SECTION 00910 - ADDENDUM NUMBER 1

- 1.01 DATE: April 17, 2013
- 1.02 PROJECT: USC One Wood Farm Equestrian Locker Room Project
- 1.03 PROJECT NUMBER: STATE PROJECT H27-Z004 A/E PROJECT 11040.02
- 1.04 OWNER: UNIVERSITY OF SOUTH CAROLINA
- 1.05 ARCHITECT: GMK Associates, Inc.

UNIVERSITY OF SOUTH CAROLINA ONE WOOD FARM EQUESTRIAN -LOCKER ROOM PROJECT BLYTHEWOOD, SC

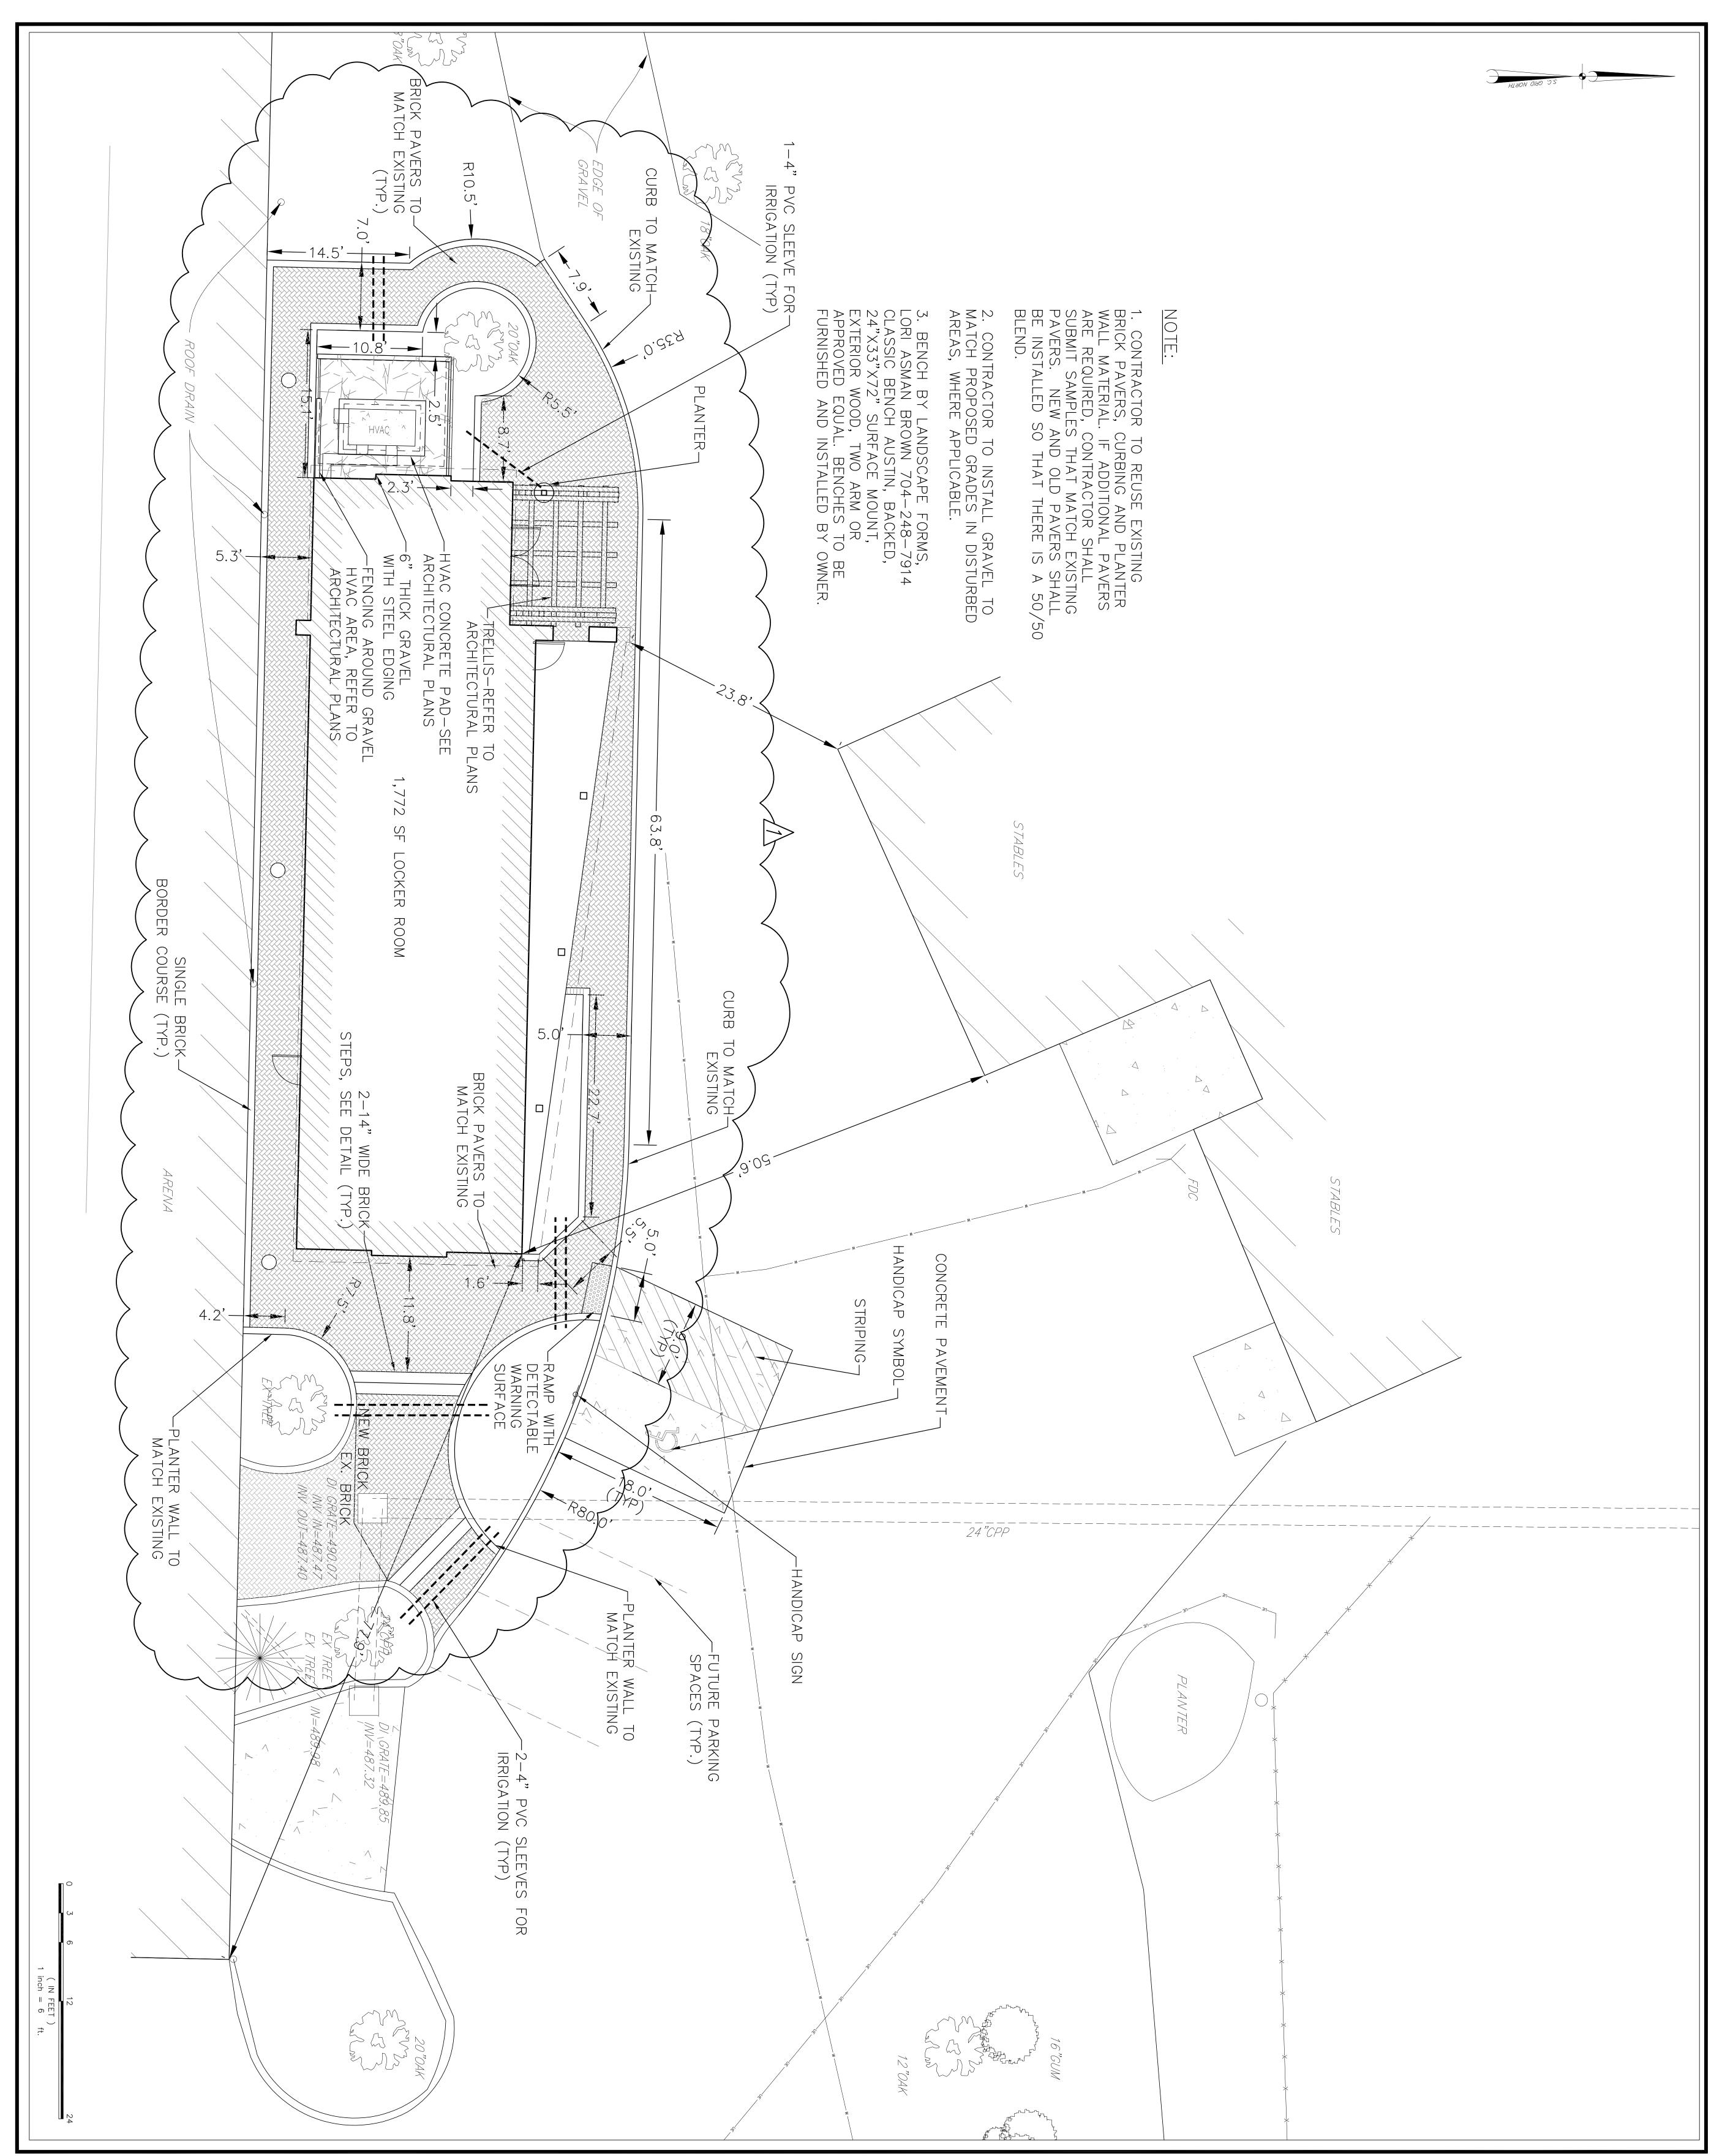
- 3.14 SECTION 15833 Centrifugal Fans
 - A. Twin City Fans is an approved manufacturer.
- 3.15 SECTION 15850 Air Outlets and Inlets
 - A. Metalaire is an approved manufacturer.
- CHANGES TO THE DRAWINGS
- 4.01 DRAWING C4.0 Layout Plan
 - A. Replace the existing drawing C4.0 Layout Plan in it's entirety with the attached revised drawing C4.0 Layout Plan.
- 4.02 DRAWING C9.0 Details
 - A. Replace the existing drawing C9.0 Details in it's entirety with the attached revised drawing C9.0 Details.
- 4.03 DRAWING A2.1 FLOOR PLAN
 - A. The wall finish material in Storage 101 (except at stone wall) shall be 5/8" paint grade hardwood veneer plywood panels (4' x 8') with 1.5" x .5" fir batten strips at joints. Panels shall be oriented vertically. Coordinate joint layout with the Architect during construction.
